LETTER OF SUBMITTAL
SAS Foundations E2/T1 Project

SUBMITTAL No: KFM-SUB-000067

Subject: CIDH Pile Placing Plan - Part A

T1 Support Brackets – Re-submittal of Submittal 67 Rev 1.

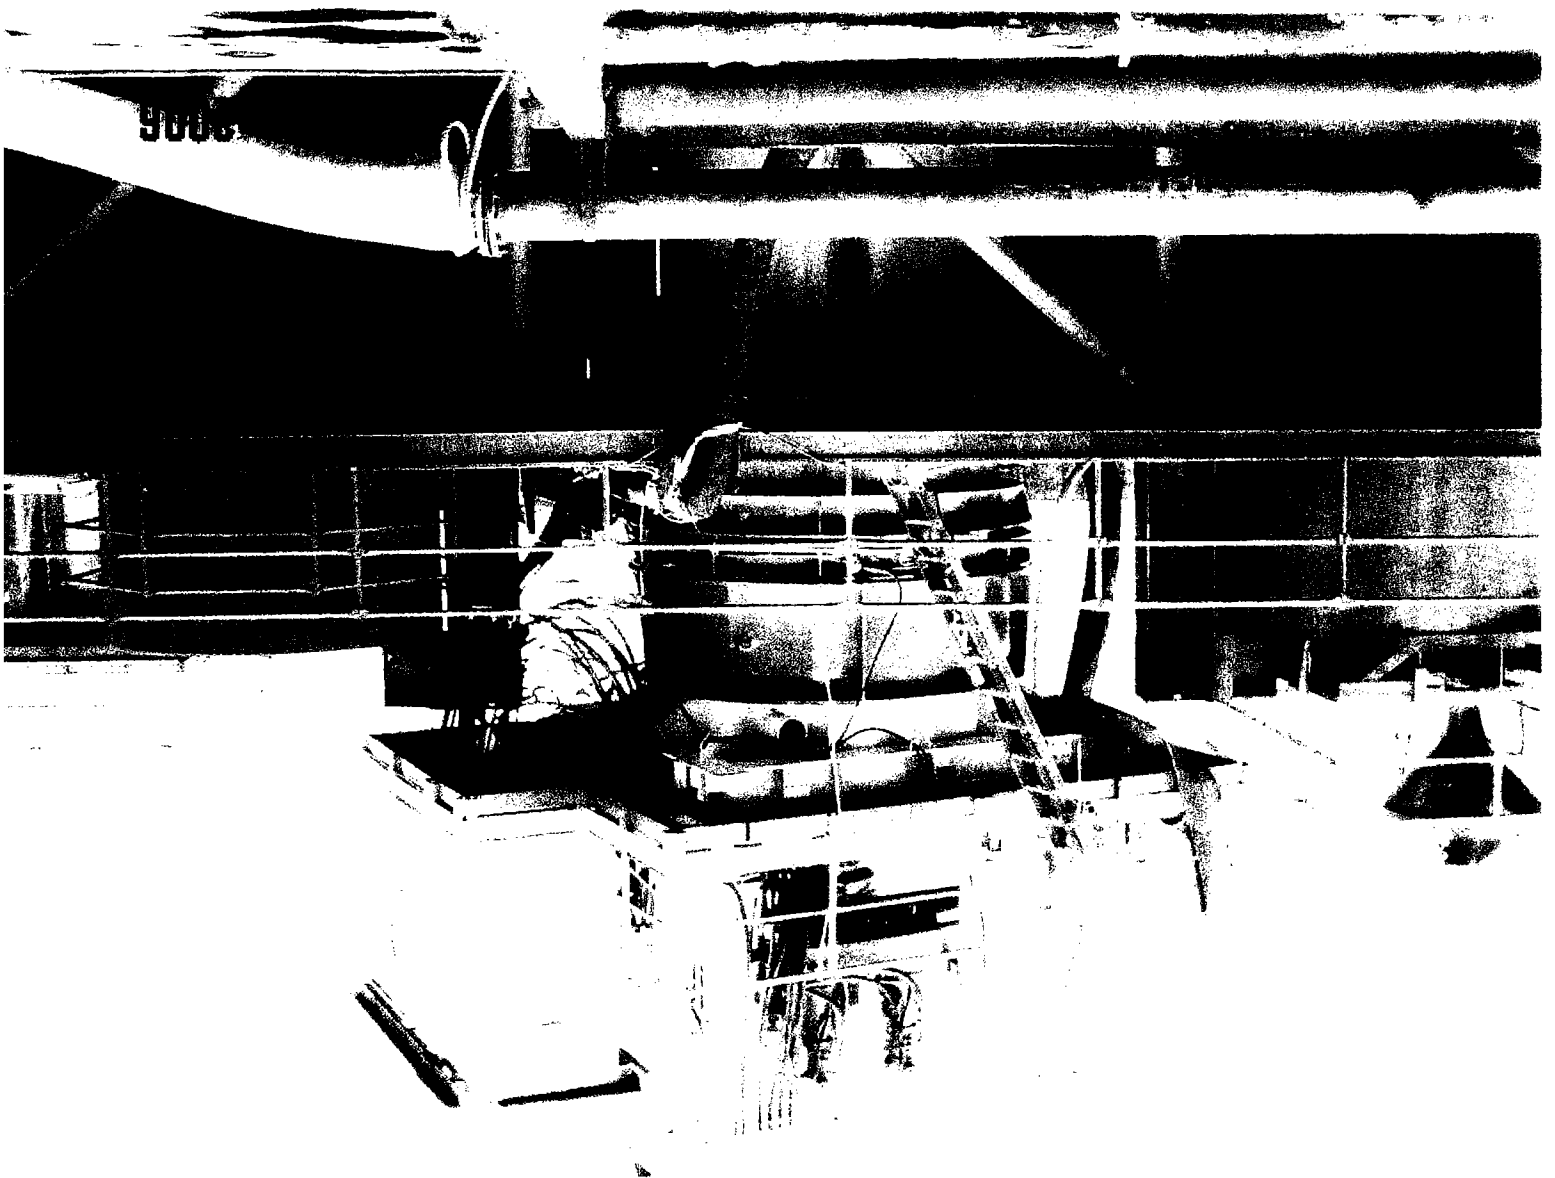
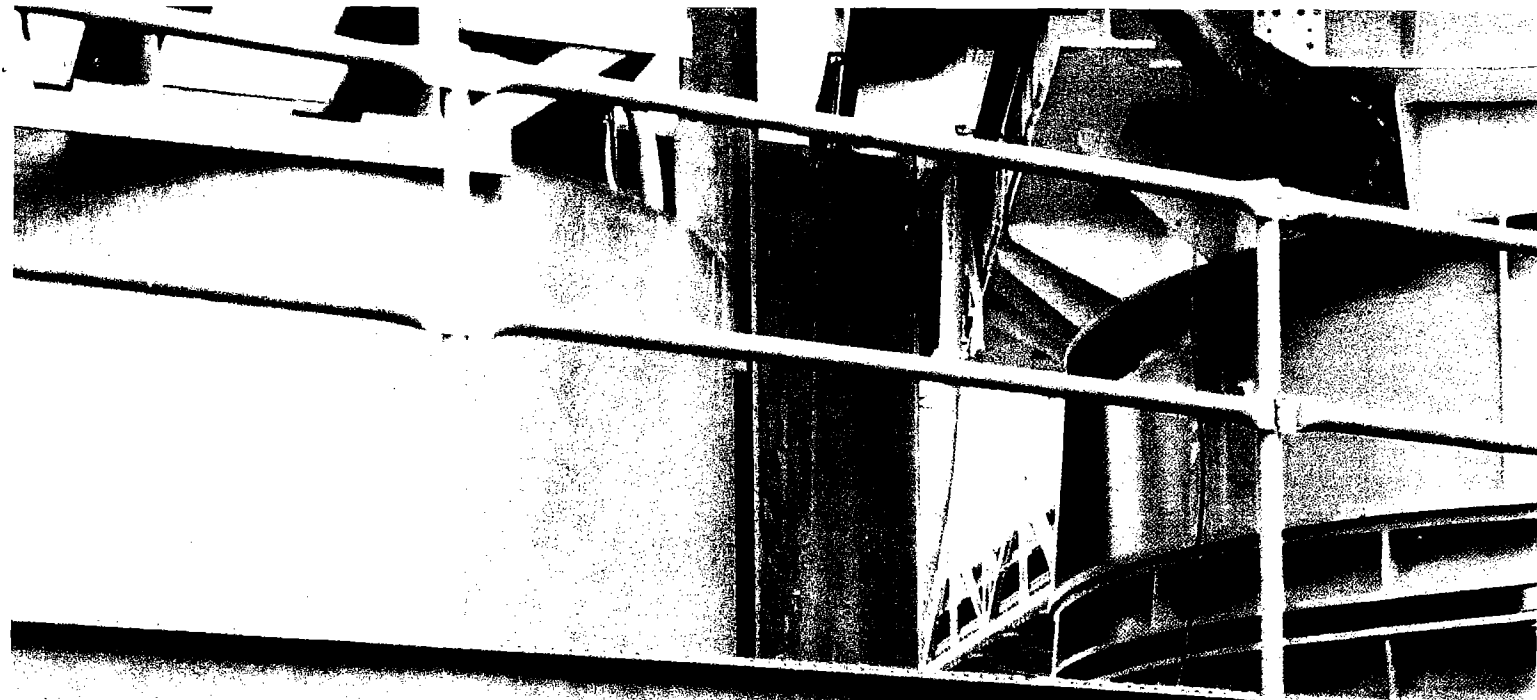
The additional brackets, as per submittal KFM-Sub-67 rev 1, are being used to assure that the temporary casing remains at its original location during the drilling operation.

As of this moment the brackets are planned to be installed prior to the point where the drill goes passed the tip of the temporary casing. The brackets are planned to remain in place until all under reaming work, with the associated back fill concrete, cured for at least 24 hrs, is completed.

The pile being drilled on will have 2 each brackets mounted on the 2 adjacent piles to provide the possible required vertical support. The template assures the vertical alignment. In addition torque plates are installed to transfer the induced torque from the drill into the template.

Please find attached pictures that show the above described set-up.
